### Lower Blacup Farm, Cleckheaton

As requested, please find attached a drawing (Ref. 1462/13) showing the location of the mine shaft (CA Ref. 418424-002) and adit (Ref. 418424-003) recorded at this site.

JOB TITLE  
**LOWER BLACUP FARM, CLECKHEATON**

DRAWING TITLE  
**MINING FEATURES & PROPOSED CLIENT LAYOUT**

DRAWN	DP	DATE	06 11 2024	STATUS	FOR COMMENT <input type="checkbox"/>
CHECKED	REG	DATE	13 11 2024	FOR APPROVAL	<input type="checkbox"/>
				DRAFT	<input type="checkbox"/>
				FINAL	<input checked="" type="checkbox"/>
SCALE	-	SHEET	A3	DRAWING NO.	1462/13
				REVISION

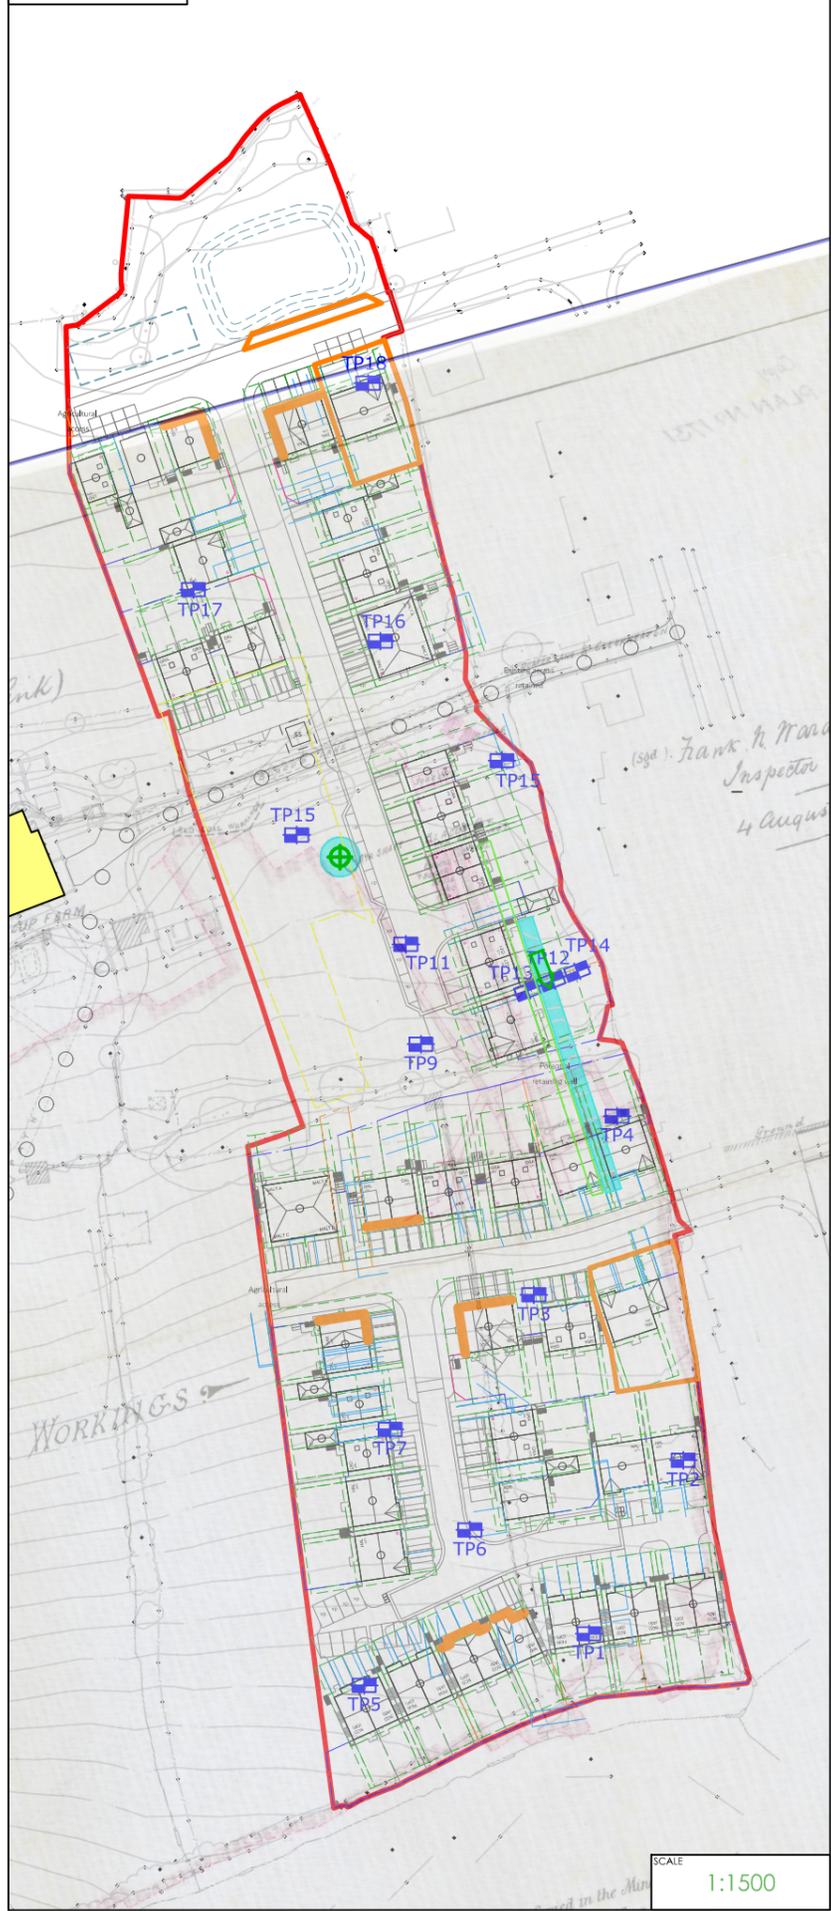
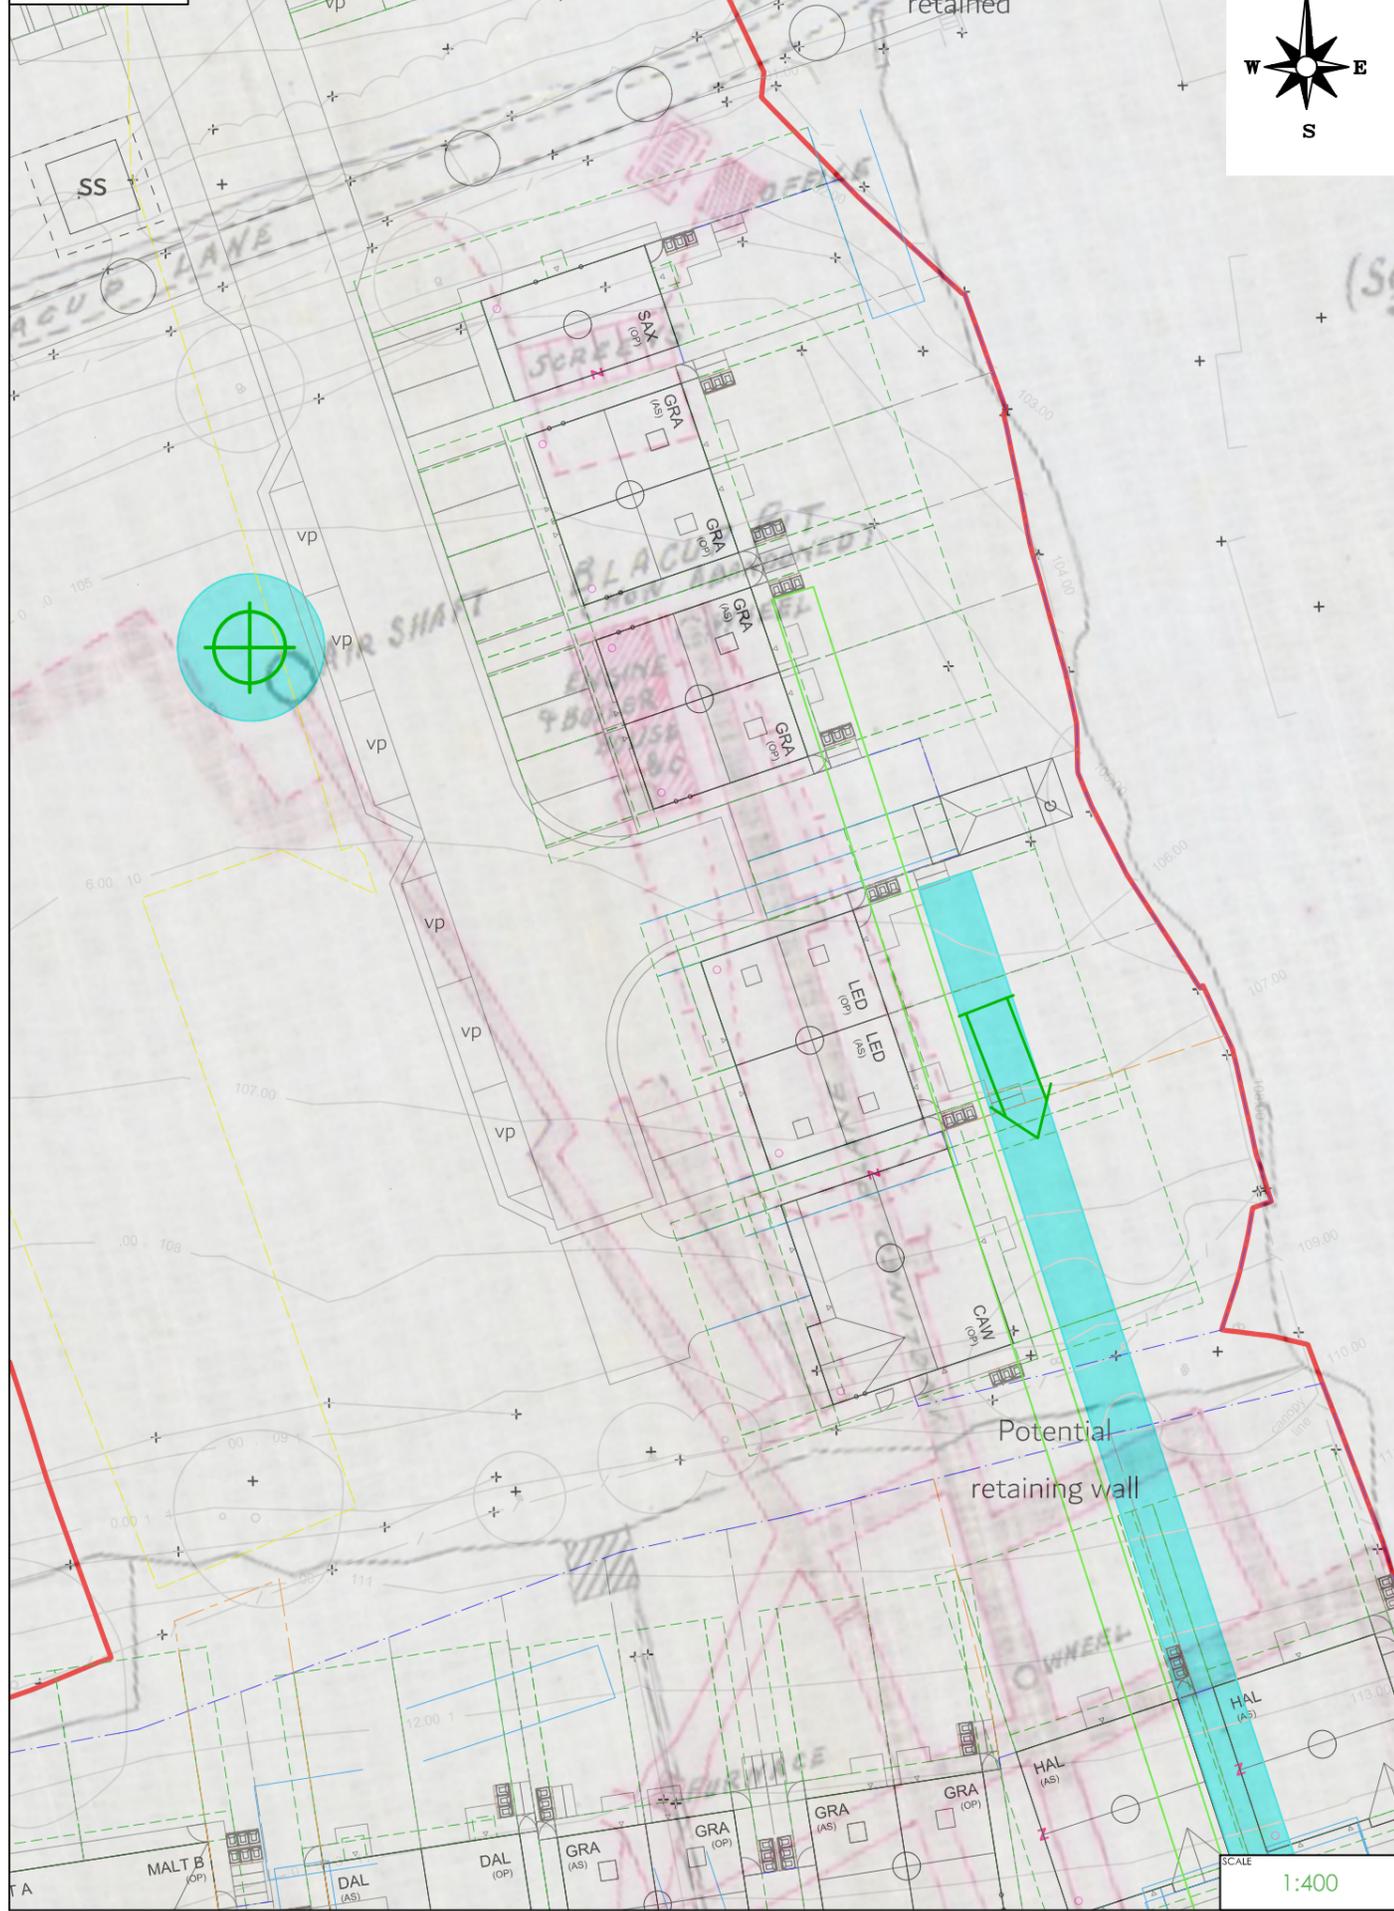
With respect to the mine **shaft** (CA Ref. 418424-002), Drawing 1462/13 shows a no-build, zone of influence around the shaft based on:

$(0.5 \times \text{assumed shaft diameter}) + \text{departure} + \text{depth to rockhead}$

$(0.5 \times 2.0) + 0 + 3.0 = \mathbf{4.0m}$

It is apparent from Drawing 1462/13 (which includes superimposition on Newett's current housing layout) that no plots are proposed within, or within 10m of, this zone of influence.

With respect to the mine **adit** (CA Ref. 418424-003), Drawing 1462/13 shows the location in which this was encountered. The line of the adit is based on that shown on CA abandonment plan (Ref 1731, dated August 1885); the abandonment plan is also superimposed on Drawing 1462/13.

Consequently, there is some uncertainty regarding the precise line of this adit. However, it is apparent from Drawing 1462/13 that the adit entrance lies within the rear garden of Plot 25, about 3.5m east of the rear elevation. The adit is expected to run beneath the rear garden of Plot 26 and then beneath Plots 27 & 28.

The line of the adit should be confirmed by drilling during the anticipated works to consolidate shallow mineworkings.

- Shaft: A reinforced concrete cap (c. 4m in diameter) at rockhead.
- Adit: Excavation until there is at least 3m of competent cover above the adit roof. The entry should then be sealed with a masonry/concrete wall, and the resultant excavation backfilled. That section of adit not overlain by ten times the adit height of competent strata should then be pressure grouted.

Provided the adit is treated as described above, development can take place above the line of an adit. Foundations of any new build plots will need to be suitably reinforced.

Adits are not like shafts and do not require a formal no-build zone, although it is generally considered prudent not to construct houses over the entrance to any adit. The adit entrance will show up on conveyancing searches, so not having a plot(s) over it may help sales.
